DANE COUNTY DEPARTMENT of PUBLIC WORKS, HIGHWAY and TRANSPORTATION

RFB NO. 309030 - ADDENDUM NO. 2

PUBLIC SAFETY COMMUNICATIONS CENTER INFRASTRUCTURE UPGRADES

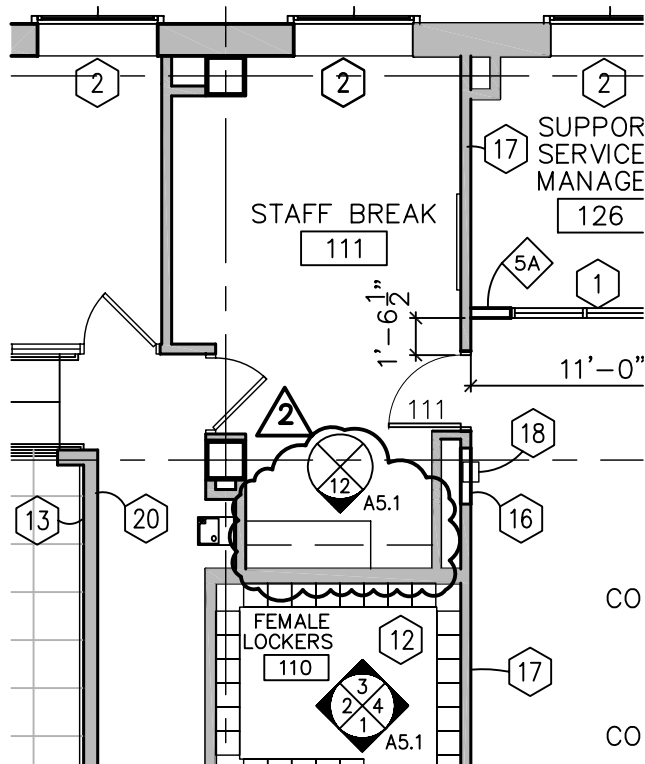
- 1) Sheet AD2.1
 - a) Drawing 1 Demolition Plan
REVISE drawing per attached drawing A/SD-7 for additional demolition.
- 2) Sheet A2.1
 - a) Drawing 1 Floor Plan
REVISE drawing per attached drawing A/SD-8 for adding new millwork in Staff Break 111.
- 3) Sheet A2.2
 - a) Drawing 1 Reflected Ceiling Plan
REVISE drawing per attached drawing A/SD-9 for soffit in Staff Break 111.
- 4) Sheet A5.1
 - a) Room Finish Schedule
REVISE room finish schedule at room 111 per attached drawing A/SD-10.
 - b) Drawing 12 New Millwork Cabinetry – Rm 111
ADD drawing 12 per attached drawing A/SD-10 for added millwork and microwave oven in Staff Break 111.

- 2
36 REMOVE PORTION OF ACCESS FLOORING FOR REPLACEMENT WITH NEW ACCESS FLOORING SUPPORTING NEW UPS UNITS. STORE PANELS FOR REUSE IN OTHER AREAS AS NEEDED.
- 37 REMOVE EXISTING BASE AND WALL CABINETS FOR NEW BASE AND WALL CABINETS

BID SET - ADDENDUM		
Dane Co Public Safety Comm Center Infrastructure Upgrades		
Madison, Wisconsin Co Bid No. 309030		ADDENDUM 2 12/30/09
		REF. SHEET H21 H/SD-5

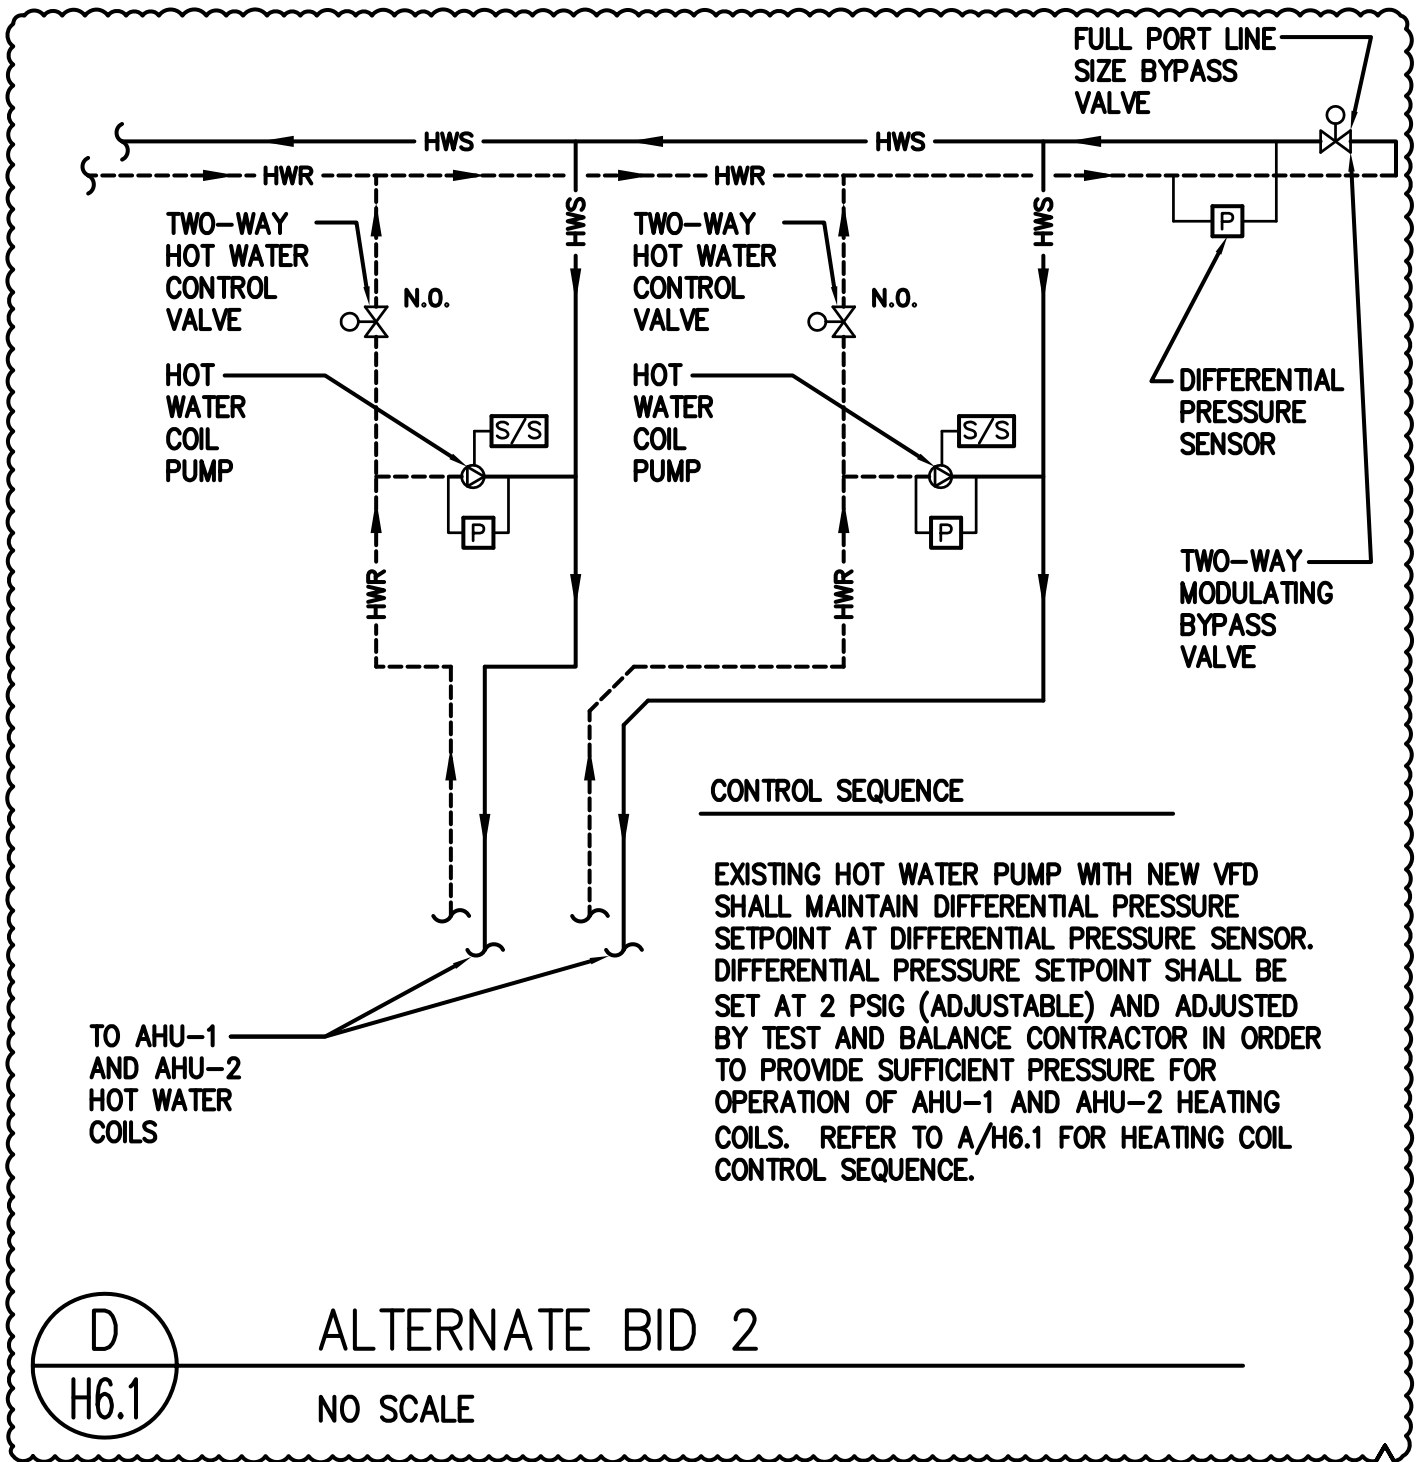
- 5) Sheet H2.1
 - a) Drawing A; HVAC New Work Plan – Ductwork
ADD plan note 7 as shown on attached drawing H/SD-5.
- 6) Sheet H2.2
 - a) Drawing A; HVAC New Work Plan – Ductwork
REVISE drawing as shown on attached drawing H2.2
 - b) Drawing B; HVAC New Work Plan – Piping
REVISE drawing as shown on attached drawing H2.2.
 - c) ADD plan notes 38, 39, 40, and 41 as shown on attached drawing H2.2.

- <4> REBALANCE EXISTING 8" DUCT TO 160 CFM.
- <5> REBALANCE EXISTING 10" DUCT TO 285 CFM.
- <6> REBALANCE EXISTING 12" DUCT TO 450 CFM.
- <7> 24/16 SA DUCT DOWN TO DISCHARGE OF CRU-3.

BID SET - ADDENDUM		
Dane Co Public Safety Comm Center Infrastructure Upgrades		
Madison, Wisconsin Co Bid No. 309030		ADDENDUM 2
		12/30/09
		REF. SHEET H6.1
		H/SD-7

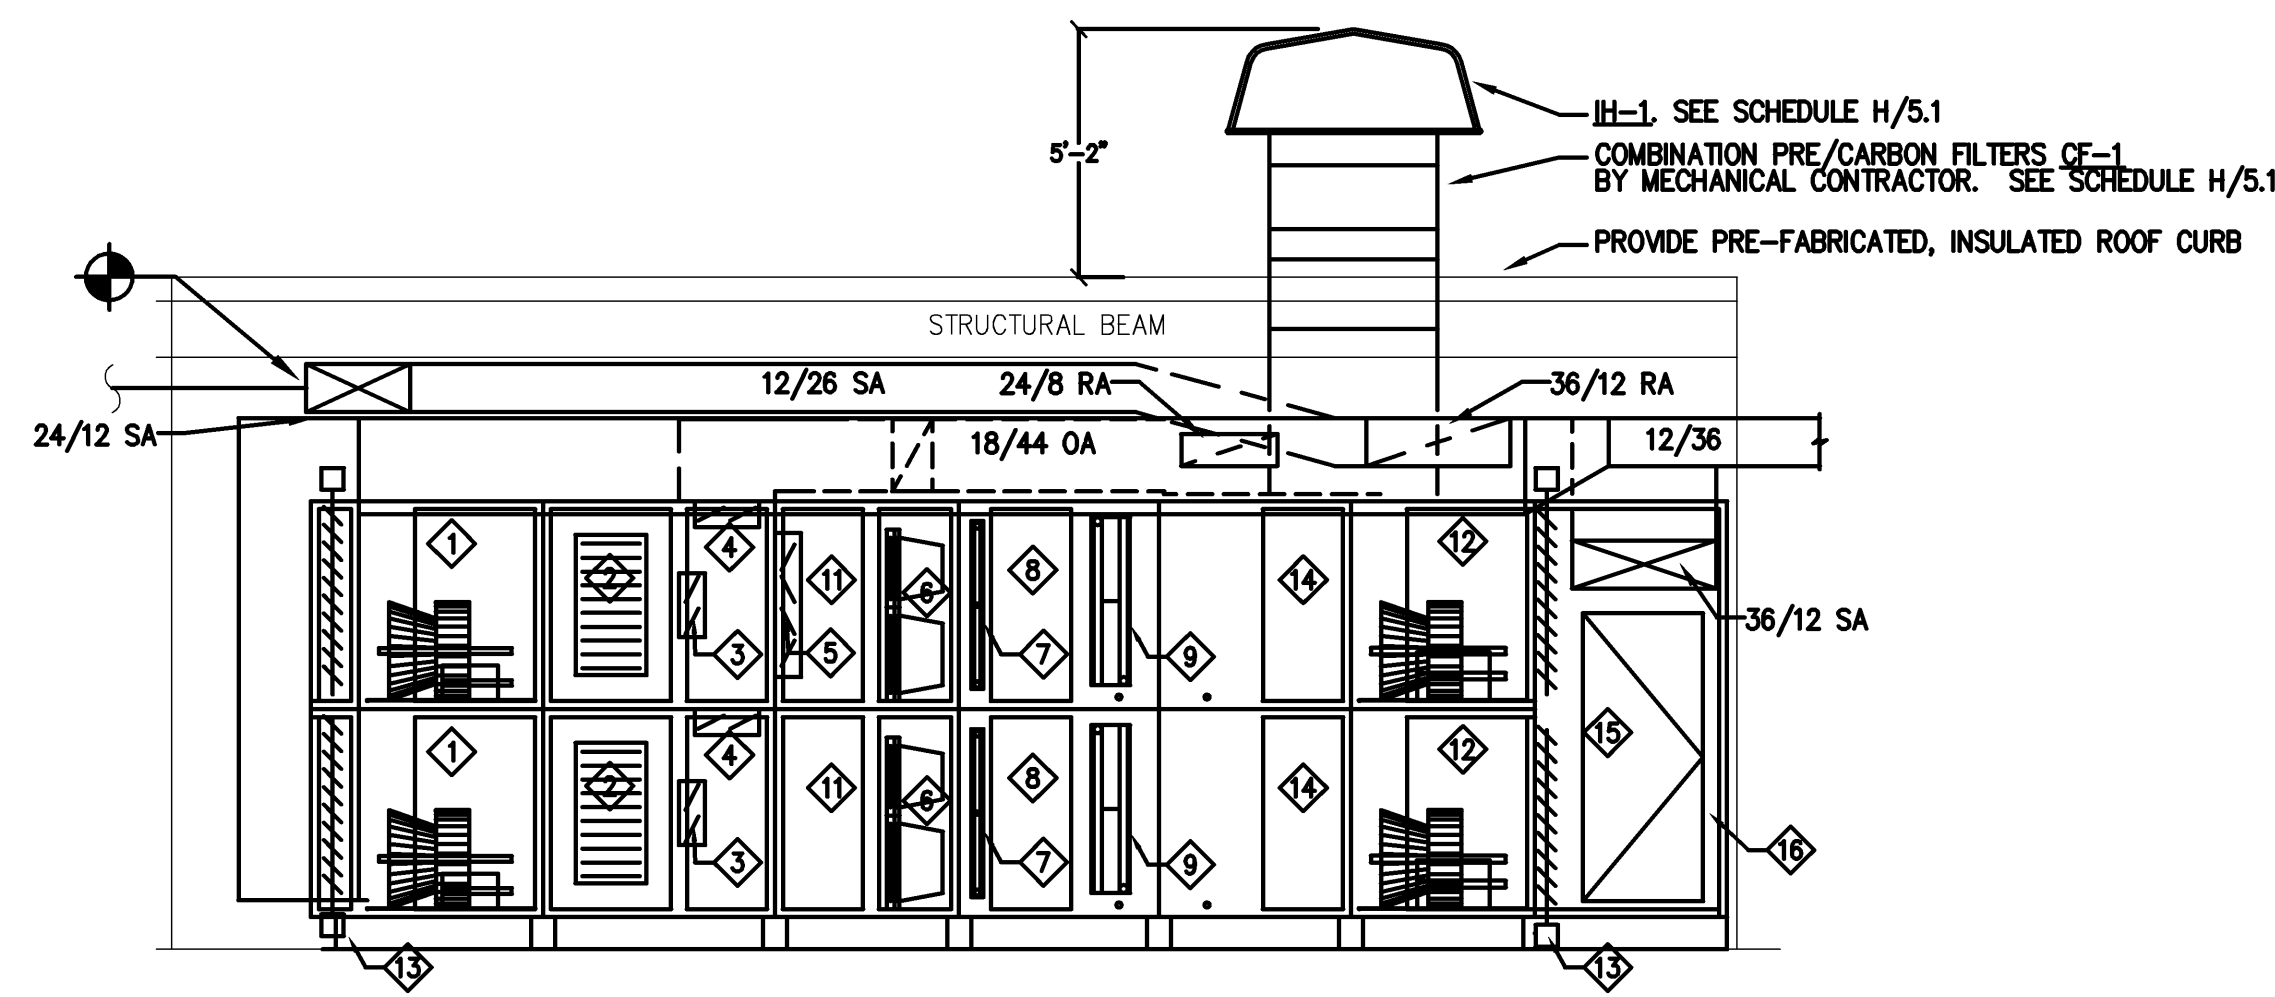
- b) Drawing B: Alternate Bid 2
ADD drawing per attached drawing H/SD-7 to control hot water pumps under Alternate Bid 2.
- 9) Sheet H6.2
a) Drawing B:
REPLACE the Emergency Power Mode section of the control sequence with the following:
EMERGENCY POWER MODE: THE BAS SHALL RECEIVE A SIGNAL FROM THE EMERGENCY TRANSFER SWITCH PROVIDED BY THE ELECTRICAL CONTRACTOR THAT THE SYSTEM IS OPERATING ON EMERGENCY POWER. REFER TO THE ELECTRICAL DRAWINGS/SPECIFICATIONS AND ELECTRICAL CONTRACTOR FOR EMERGENCY POWER SEQUENCE. PROVIDE THE FOLLOWING SEQUENCE DURING EMERGENCY POWER:

BID SET - ADDENDUM		
Dane Co Public Safety Comm Center Infrastructure Upgrades		
Madison, Wisconsin Co Bid No. 309030	ADDENDUM 2 12/30/09	REF. SHEET ED.1.1 E/SD-4

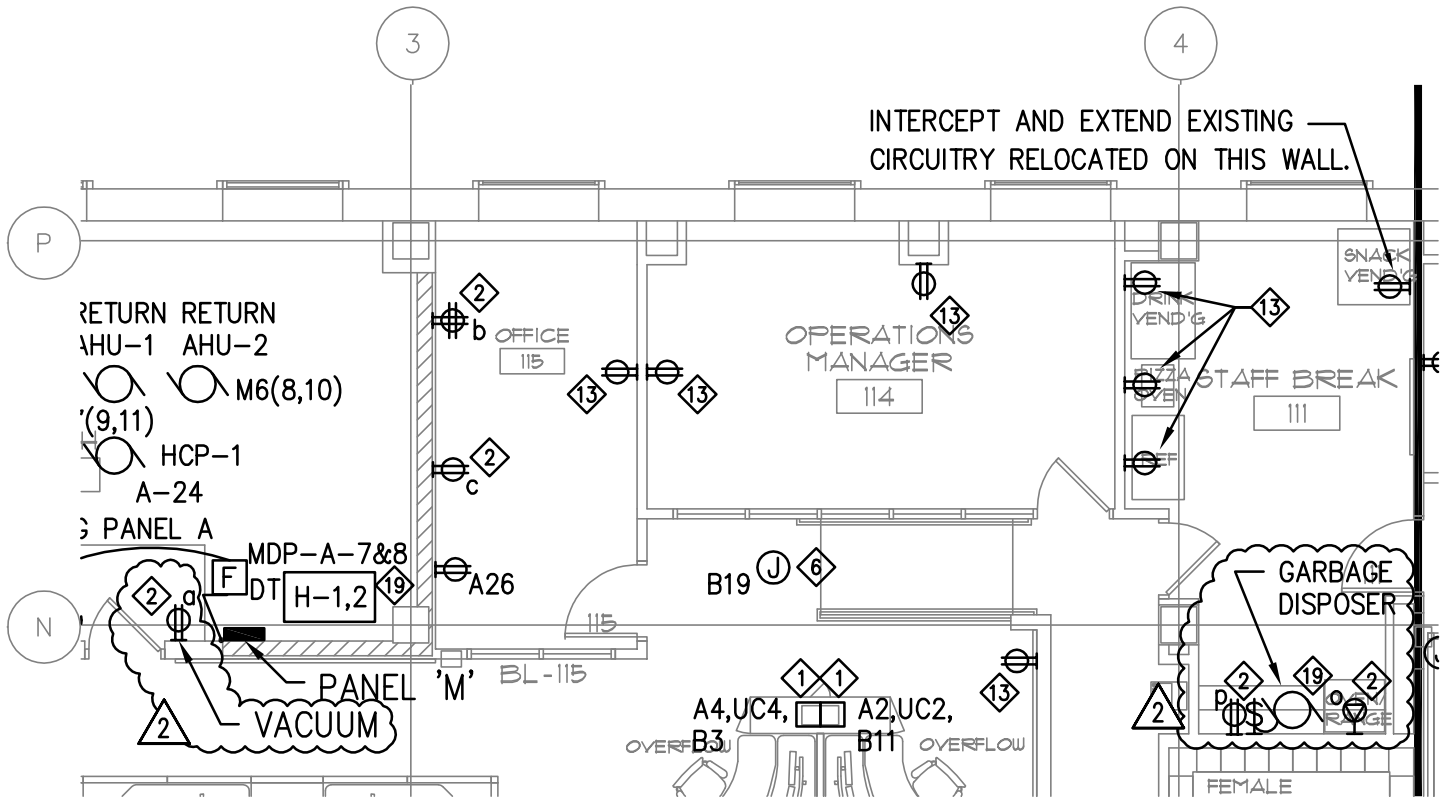
- 10) Sheet ED1.1
 - a) Drawing A; Electrical Demolition Plan - Power
REVISE drawing per attached drawing E/SD-4 for existing devices to be demolished, and/or relocated.

16 DISCONNECT EXISTING CIRCUITRY AND SWITCH ASSOCIATED WITH THE GARBAGE DISPOSER. REUSE EXISTING CIRCUITRY ONLY.

BID SET - ADDENDUM		
Dane Co Public Safety Comm Center Infrastructure Upgrades		
Madison, Wisconsin Co Bid No. 309030		ADDENDUM 2
		12/30/09
		REF. SHEET E2.1 E/SD-5

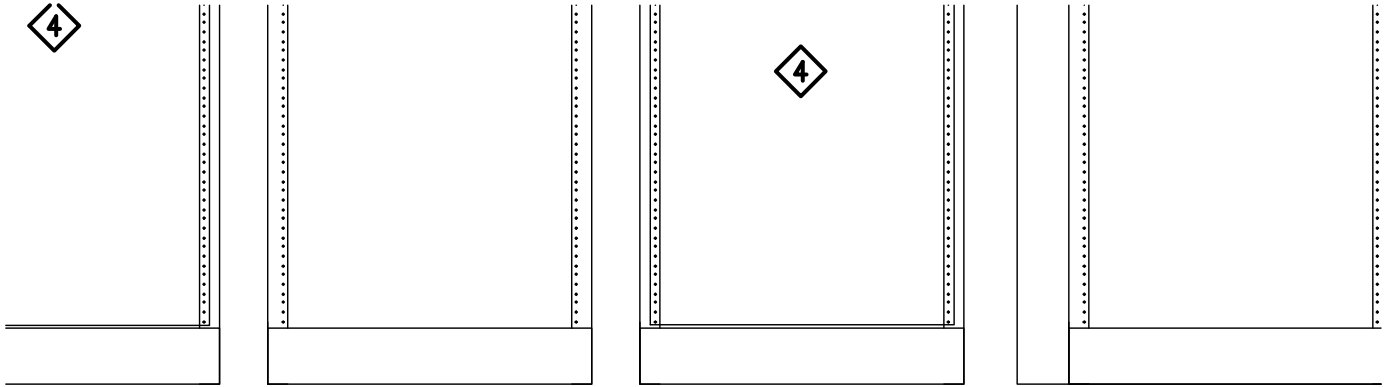
- 11) Sheet E2.1
 - a) Drawing A; Electrical New Work Plan - Power
REVISE drawing per attached drawing E/SD-5 for addition of new devices to be provided, and/or relocated.

- b) Drawing A; Electrical New Work Plan – Power
DELETE starter/disconnect associated with UH-1.
ADD 20/1P disconnect mounted on unit.
- 12) Sheet E4.1
 - a) Light Fixture Schedule
REVISE fixtures type L1, L2, L3: Provide diffuse reflector with white trim.

19 REUSE EXISTING CIRCUITRY AND PROVIDE NEW SWITCH AS INDICATED, MOUNT 6" ABOVE COUNTERTOP.

C
T2.1

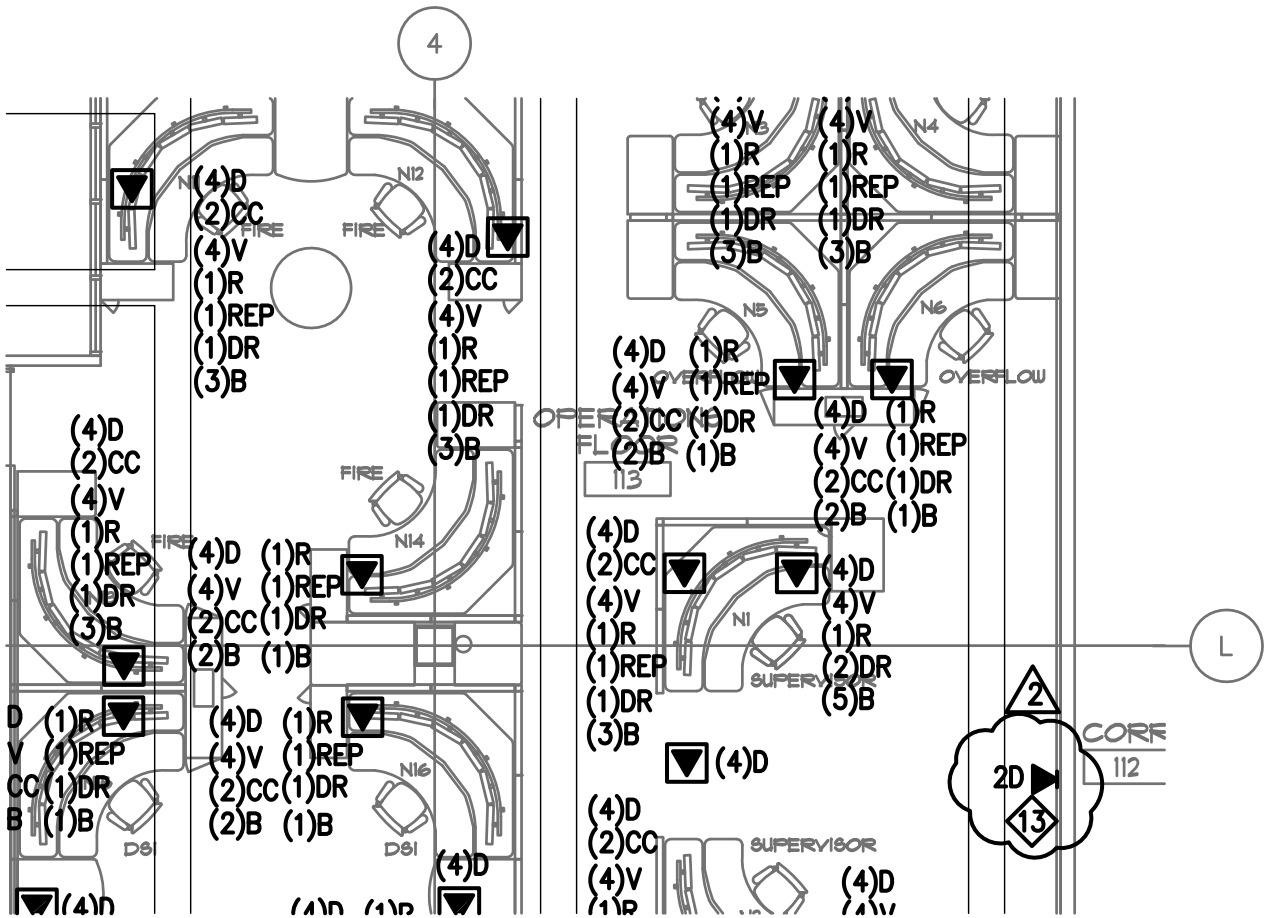
- 14) Sheet T2.2
 - a) ADD entire drawing attached.
- 15) Sheet T2.1
 - a) REVISE detail C/T2.1, detail note 6 to read as shown on attached drawing T/SD-1.
 - b) ADD plan note 13 to detail A/T2.1 as shown on attached drawing T/SD-2.
- 16) Sheet TT1.1
 - a) ADD plan note 25 to detail A/TT1.1 as shown on attached drawing T/SD-3.

- 6 PROVIDE (1) 12 STRAND 62.5 MICRON PLENUM RATED MULTI MODE FIBER OPTIC CABLE. FIBER TO BE SUITABLE FOR INSTALLATION IN FREE AIR, IN BUILDING RISERS, IN CONDUIT, IN INNER DUCT, SUITABLE FOR USE IN VERTICAL SHAFT OR FROM FLOOR TO FLOOR AND SHALL BE UL LISTED AS HAVING FIRE-RESISTANT CHARACTERISTICS. PROVIDE LC TYPE FIBER OPTIC CONNECTORS: PANDUIT, CORNING, SIEMON OR PRE-APPROVED ALTERNATE. REFER TO SHEET T2.2 FOR ROUTING OF CABLE FROM EXISTING COMPUTER ROOM 120 TO EXISTING THIRD FLOOR TELECOMMUNICATIONS ROOM.
